DESCRIPTIVE REPORT

Registry No. H10857

Locality Goose Creek to Red Bank Landing

**ATLANTIC HYDROGRAPHIC BRANCH
EVALUATION REPORT FOR H10857 (1999)**

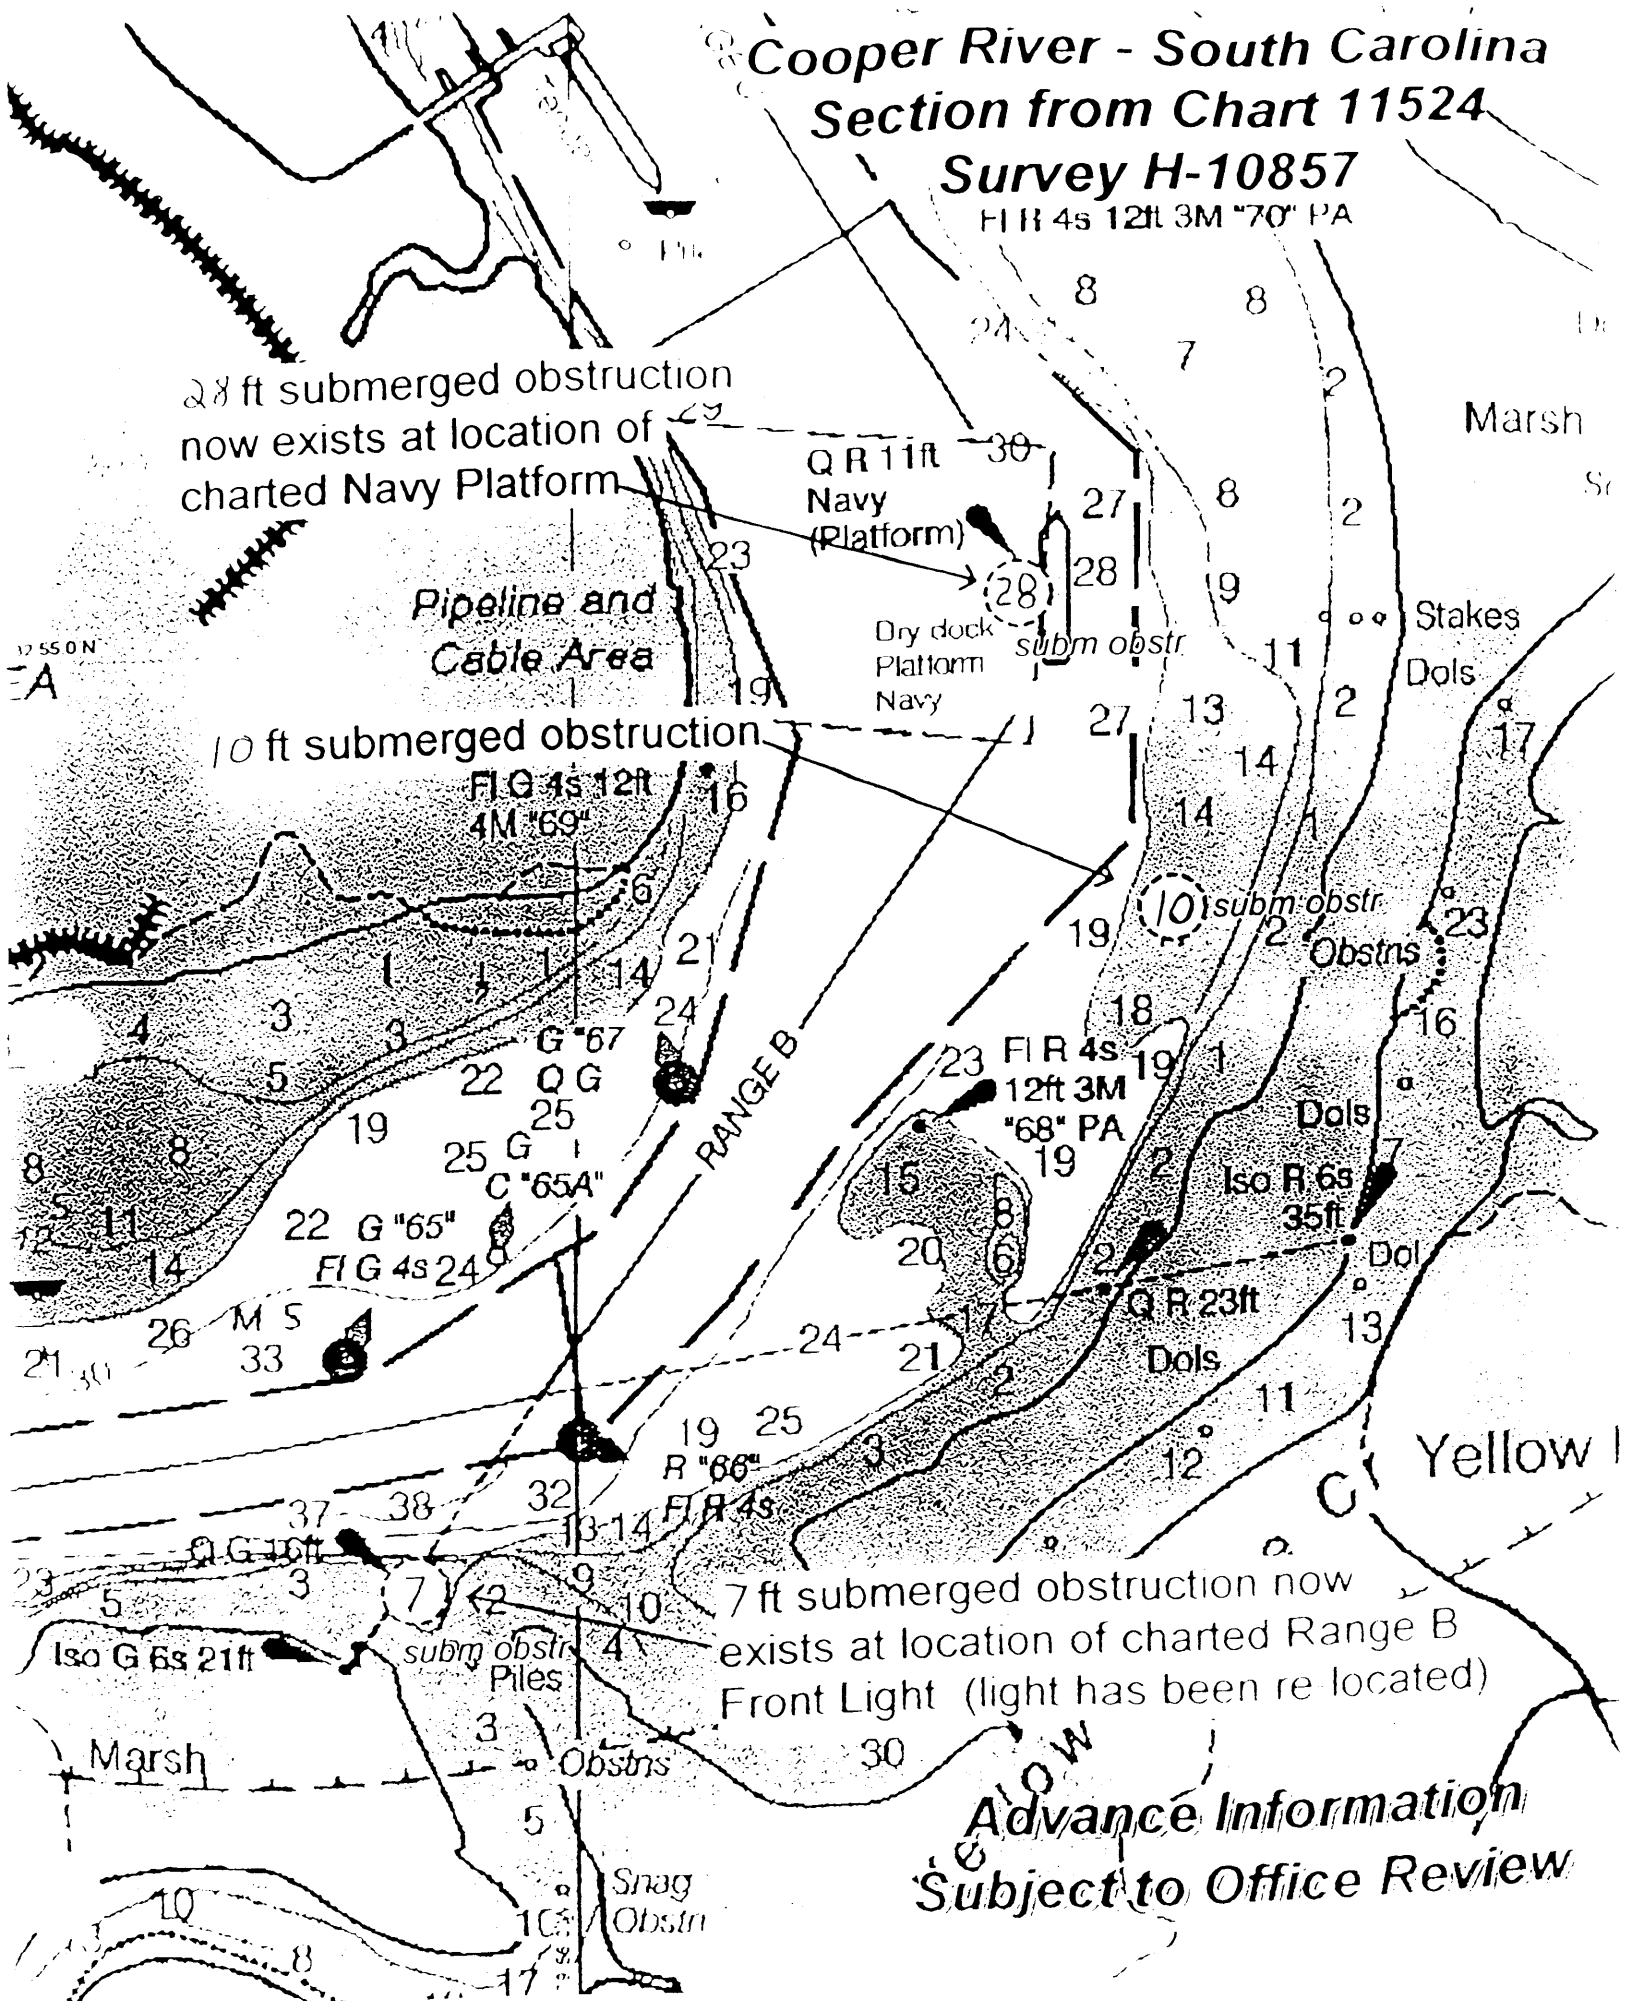
Description	NAD 83 Position	Depth (ft) MLLW
Submerged Obstruction	32°55'01.31"N 079°55'41.32"W	28
Submerged Obstruction	32°54'50.16"N 079°55'35.08"W	10
Submerged Obstruction	32°54'26.66"N 079°56'07.16"W	7

The attached chartlet depicts the items addressed in this letter.
